**STAFF REPORT
(Preliminary Plat)**

CASE NUMBER: S/D 91-46 - STONE BOROUGH ADDITION

**STAFF REPORT
(Preliminary Plat Approved 10/31/91)**

STAFF REPORT

VICINITY MAP:

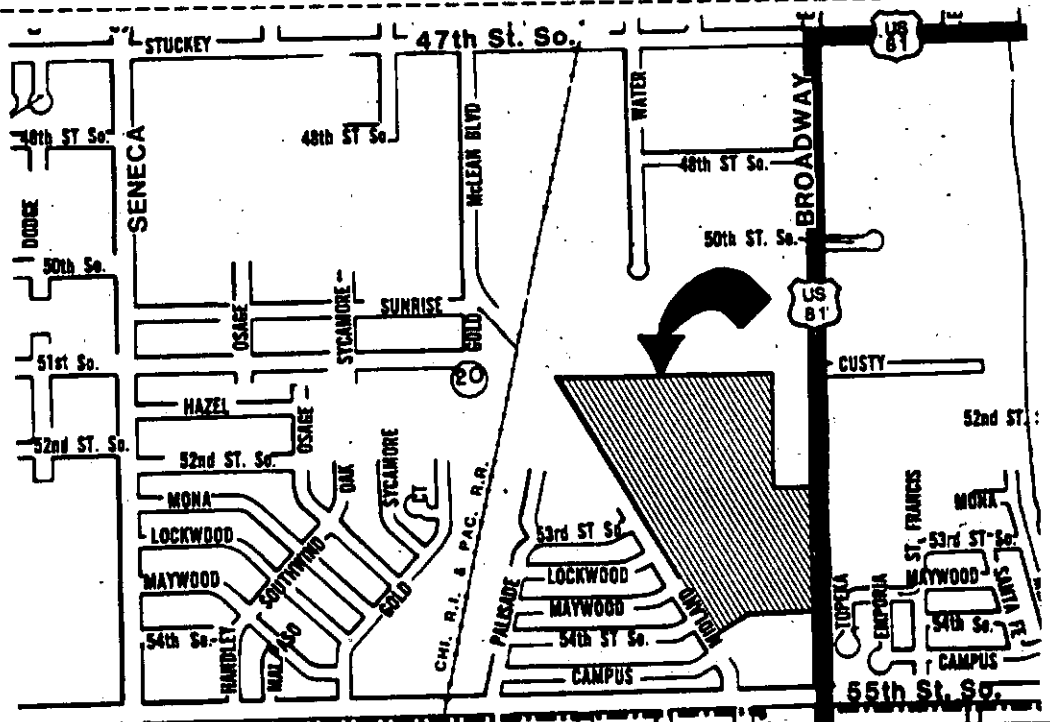
- A. The applicant shall guarantee the extension of sanitary sewer to serve the lots being platted.
- B. The applicant shall guarantee the extension of City water to serve the lots being platted.

- C. The applicant shall guarantee any drainage improvements required by the platting of this property. *channel improve.*
- D. The applicant shall guarantee construction of the storm sewers required by this plat.

- E. The applicant shall guarantee the paving of the proposed interior streets.
- F. As required by the sidewalk ordinance, sidewalks shall be guaranteed on both sides of 53rd St. S. (a collector) and on one side of the two major street loops; ie Park Place-Custy-Stone Borough and Market-Maywood-Stone Borough (both streets are long continuous street segments, intersecting a collector, with more than 48 lots accessing the street). *by Sidewalk Certificate?*

- Don't know*
G. Traffic Engineering needs to indicate any traffic improvements required for this site; specifically in regard to the one major entrance into the site off of Broadway.

- I. This site is effected by a number of zoning issues. A significant portion of this site along Broadway is under "C" Commercial Zoning. Not only is this incompatible with the intended residential use being platted, but such zoning would also require streets in this area to meet the commercial street standard (70 ft. right-of-way, 41 ft. paving). An appropriate rezoning should be requested. Approval of such a zone change should be obtained prior to this plat being scheduled for City Council review.

- J. Fifty-fourth Street to the south of this plat has been dedicated. This proposed plat, however, makes the need for this street impractical. The applicant shall therefore submit a separate vacation request for this street.

- K. The representative from the City's Fire Department should be prepared to indicate if access into this development is adequate for safety considerations. Only one main entrance is shown for the site from Broadway. A secondary entrance to the west is somewhat indirect, crossing by way of a bridge over a drainage ditch that runs along the west line of the addition.

- P. City Engineering should also be prepared to indicate if any additional right-of-way is required at this location. The addition immediately north dedicated 60 feet of half street right-of-way, while this plat is showing 58.5 feet. The typical requirements for an arterial such as Broadway would only be 50 feet of half street, unless it was a Federal Aid Primary or Secondary highway in the County, in which case 60 feet would be required.

- Q. Upon the recording of this plat, 53rd Street South shall become a designated residential collector street.
- R. Prior to or at the time of submitting the final plat, the applicant shall submit a drainage plan to City Engineering for review and approval.

- W. The representatives from the utility companies should be prepared to comment on the need for utility easements to be platted on this property.
- X. It can be noted that the layout of this plat, especially in terms of the culs-de-sac stemming from Stone Borough, may result in excessive travel. With the main entrance to the subdivision being from Broadway, people trying to access the lots adjacent to these culs-de-sac must drive around to the west end of the addition in order to go back east into the cul-de-sac. Significantly less driving would be possible if the culs-de-sac stemmed from Market or Park Place. Drainage may be part of the consideration in the present design. The applicant's agent should be prepared to explain the reason for the proposed layout.

- Y. The representative from City Engineering should be prepared to comment on the status of the applicant's drainage concept.

VICINITY MAP:

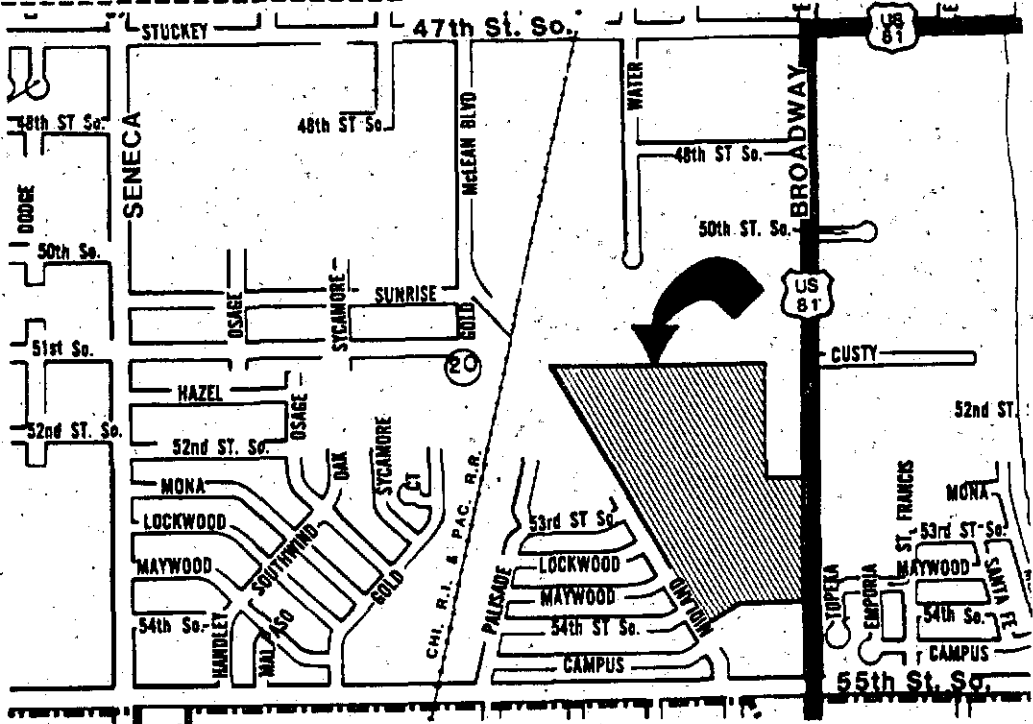
NOTE: One additional lot has been created in Block 4 by the shifting of lot lines.

- C. The applicant shall guarantee any drainage improvements required by the platting of this property. This guarantee shall provide for any improvements required for the drainage ditch adjacent to this site.

- F. As required by the sidewalk ordinance, sidewalks shall be guaranteed on both sides of 53rd St. S. (a collector) and on one side of the two major street loops; i.e. Park Place-Custy-Stone Borough and Market-Maywood-Stone Borough (both streets are long continuous street segments, intersecting a collector, with more than 48 lots accessing the street). Such guarantees are typically included in the street paving guarantee. However, the applicant should meet with Planning and City Engineering to determine if an alternate method may be used.

- G. The Kansas Department of Transportation (KDOT) has indicated some concern with access to Broadway (U.S. 81). The applicant should contact KDOT to determine if the state has obtained any control of access at this location.

- K. The final plat tracing shall indicate the utility easements requested by K.G. & E. The representative from K.G. & E. should indicate if the additional lot on Block 4 alters their requested easements.

- O. The applicant shall submit a covenant which provides for four (4) off-street parking spaces per dwelling unit on each lot which abuts a 58-foot street. The covenant shall inventory the affected lots by lot and block number and shall state that the covenant runs with the land and is binding on future owners and assigns.

- P. The final plat tracing shall indicate the required minimum building pad elevations.
- Q. Line 16 and 17 of the platting binder's legal description contains a typographical error (bearing N29 29 deg 32'13"). A corrected legal shall be submitted.

VICINITY MAP:

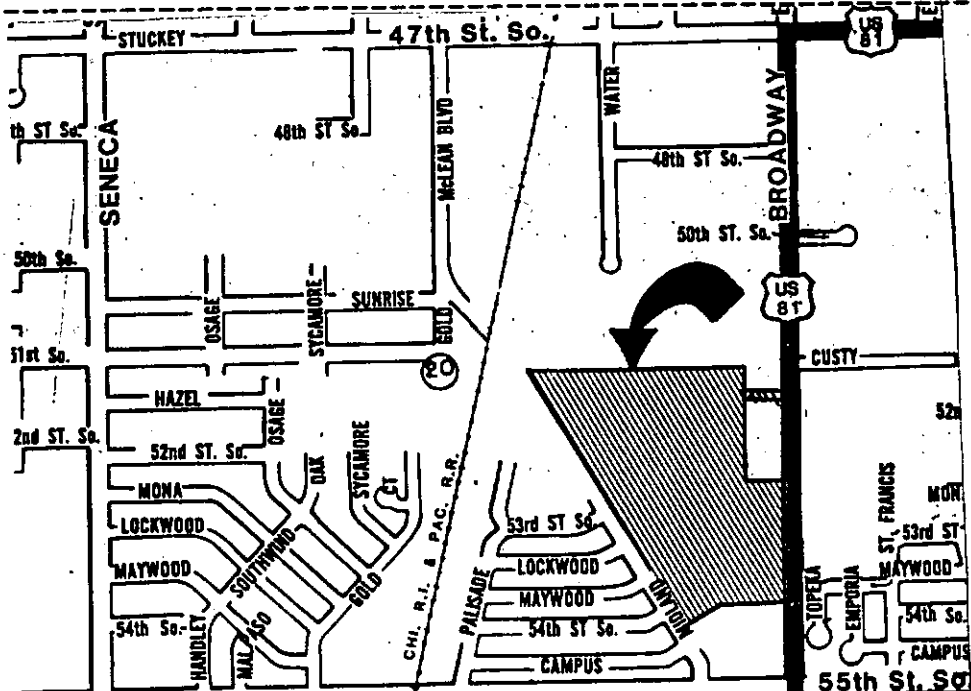
NOTE: This plat involves a revised final plat of the plat approved by the Planning Commission, December 5, 1991. The primary reason for this revision is to remove the street connection for 53rd Street South at the west line of this plat. As a result of this change, the applicant is also proposing to add one additional street segment and opening out to Broadway, reducing the width of 53rd Street from a collector status (66 foot right-of-way) to a 64 foot local residential street, granting a drainage easement in the previous 53rd Street connection, and creating one (1) additional residential lot. With the change in 53rd Street's right-of-way, lot dimensions have also been adjusted either side of this street.

The applicant's desire to revise this plat in order to remove the 53rd Street connection is because of the cost involved in building a crossing or bridge over the drainage ditch that runs along the west line of this plat. As was indicated during the review of this plat the area to the west of this site was platted, and has partially been developed, with a collector street intended to cross this ditch and subsequently connect to this site in the area platted for 53rd Street South. When the areas to the west were originally platted bridges or crossings of such drainage ditches were provided by the City at large. This policy though is no longer in effect and this plat would be required to guarantee this crossing.

Besides for the already platted (and partly built) collector system to the west of this ditch (Palisade/53rd St. S.) this addition's residential development pattern further implies that a collector street should be provided in this addition, and as originally platted, connecting to the collector street to the west. Connections across similar drainage ways is not an exception in this community but rather are quite common.

The issue in this case is not really whether a collector system should be provided as shown on both the previous plats and the original final plat of this site, but rather how the crossing of the ditch is to be paid for. That is, it is the Planning Department's position that this revised plat not be approved and that the applicant's original final plat stand, with the applicant needing to pursue an acceptable means for guaranteeing the crossing of the ditch.

Option 1. As indicated above, disapprove the revised final plat and require the applicant to continue pursuing completion of the plat as originally approved.

Option 2. Accept a revised final plat similar to what was submitted but with a contingent street dedication for the 53rd Street stub connection to the west. That is, the second entrance

from Broadway is to be provided in addition to the contingent dedication. Some form of agreement should also be provided for this property to participate in any future crossing of this ditch. Also, 53rd Street should continue to be platted as a collector, i.e. 66 foot right-of-way.

Option 3. Accept the revised plat as submitted.

- O. The final plat tracing shall indicate the required minimum building pad elevations.
- P. On the final plat tracing the street name Main shall be used instead of Park Place.

- Q. As requested by K.G. & E., the final plat tracing shall indicate a 10-foot easement between lots 25 and 26, and between 10 and 11, Block 4 instead of between lots 24 and 25 and between 11 and 12.

- R. As requested by K.G. & E. the applicant shall meet with K.G. & E. to determine if a 5-foot private easement will be needed along the east line of the plat.

- A. The comment on drainage and paving shall be revised to indicate the appropriate requirements.
- B. Sidewalk requirements shall be adjusted accordingly, i.e. if 53rd St. is not a collector sidewalk is only required on one side, but sidewalk shall be guaranteed along the second street (Hazel) being extended out to Broadway.
- C. As appropriate any comments concerning 53rd St. S. being platted as a collector shall be revised.
- D. Hazel's intersection with Broadway shall not be indicated as a solid line.
- E. A revised platting binder shall be submitted indicating that the property being dedicated for Hazel's extension out to Broadway is in the applicant's ownership.
